Site: La Cuentista Unit 2

Re: Drainage Ordinance (14-5-2-1) Violations for Erosion and Sediment Control

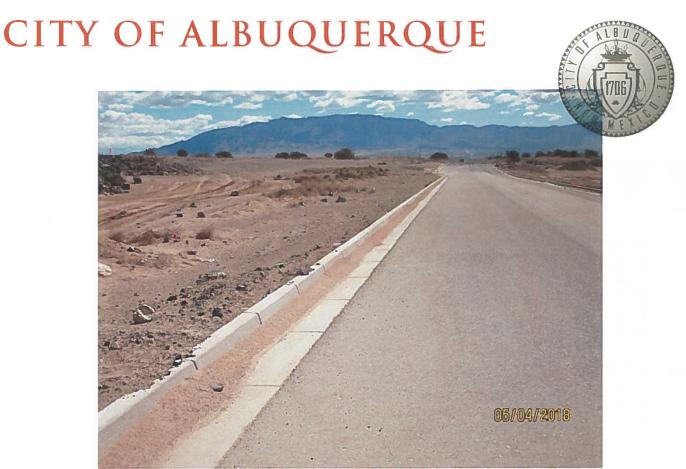
- 1. There was sediment in the gutters on Rosa Parks Rd and Kimmick Dr.
- 2. Dirt ramps were built in Rosa Parks Rd to facilitate transporting material across the roadway.
- 3. There was no vehicle tracking control for vehicles transporting material across Rosa Parks Rd.
- 4. The silt fence along Kimmick drive requires maintenance/replacement.
- 5. Workers are exiting the site at Red Root St. There is no vehicle tracking control.
- 6. A sediment BMP (e.g. rock bags or mulch sock) is required on the concrete apron at Red Root St.
- 7. The silt fence has fallen/blown into the roadway in Kimmick ave.
- 8. Self-inspection reports were not provided upon request.

Sediment in gutter Rosa Parks Rd; south gutter.

- 1. Remove sediment from the gutters on Rosa Parks Rd and Kimmick Dr. and prevent from occurring in the future.
- 2. Remove dirt ramps from Rosa Parks Rd that were placed to facilitate transporting material across the roadway and do not construct dirt ramps in the streets in the future.
